Appl. No.: 10/707,549 Amdt. Dated: 1/31/2005

Reply to Office action of: 11/26/2004

## **AMENDMENTSTOTHEDRAWINGS:**

## REMARKS/ARGUMENTS

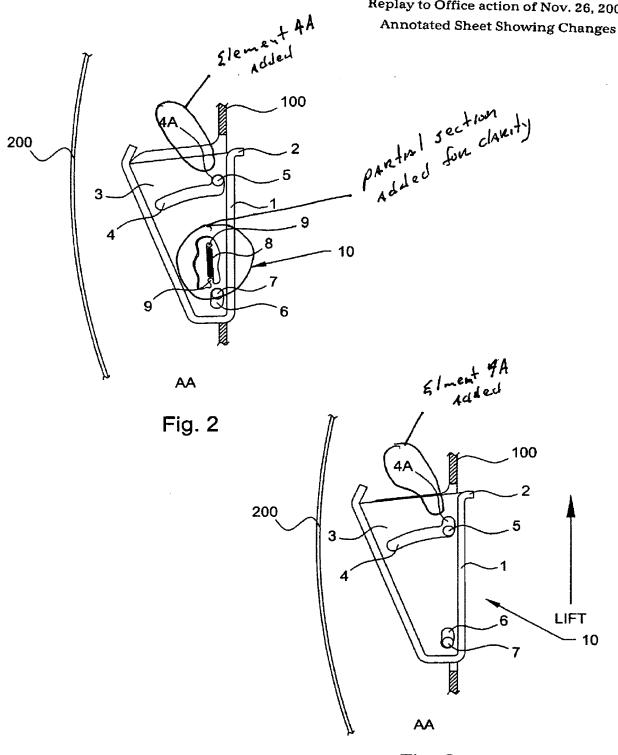
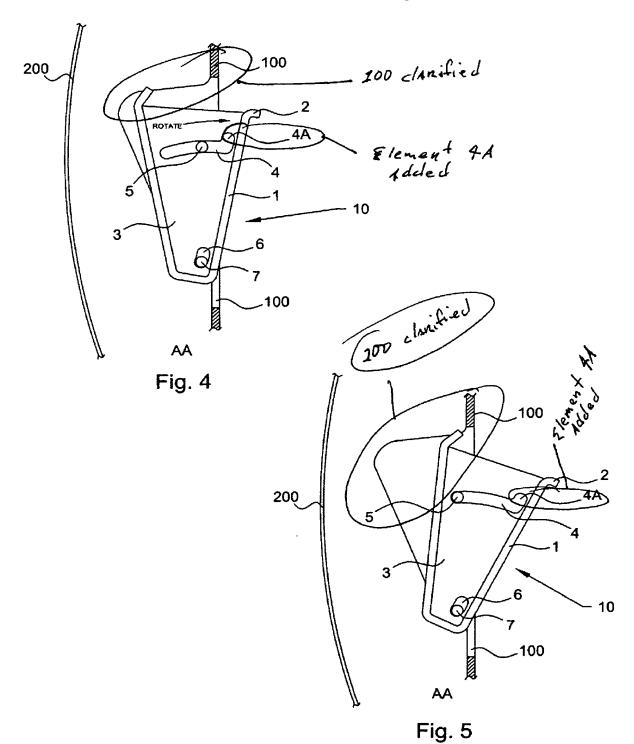
The attached sheet(s) of drawings includes changes to Figures 2, 4, 5, 8, 9, and 10. The sheet containing Figure 2 has been amended to provide a partial sectional view of the area of the articulating storage bin wall allowing for more clear illustration of the manner of attachment of spring 8 to lower pin 9 located on the exterior wall of said bin and the upper pin 9 located on the door trim panel 100. The sheet containing Figures 4 and 5 has been amended to properly label locking detent portion 4A in each figure, provide a clearer indication of the relationship between the storage bin 10 and the trim panel 100, as well as more clearly illustrate the guide trough 4 in the storage bin wall and the boss 5 located on the door trim panel 100. The sheets containing Figures 8 – 10 have been amended to more clearly illustrate the location and action of spring 80 and spring retaining clip 81 located on the door trim panel 100 and the boss 5 located on the articulating storage bin 10.

In amended Figures 2, 4, 5, 8, 9, and 10 the drawings have been corrected to show more clearly the claimed invention and to overcome the Examiner's objections.

Fig. 9

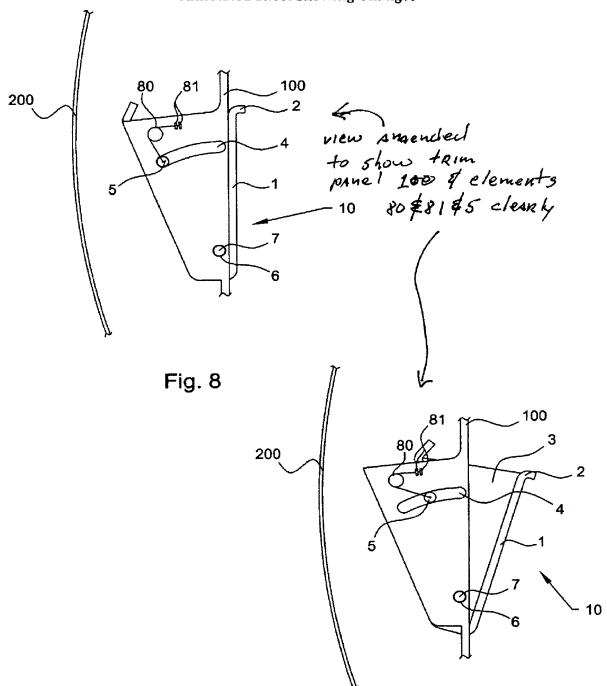
Applicants respectfully traverse this rejection. In light of the corrections to the drawings containing Figures 8-10 the manner of cooperation of the spring between the storage bin and door trim panel is now very clear. In light of the amendments to the Figures 8-10 this basis of rejection is now moot and Applicants respectfully request the removal of said rejection.
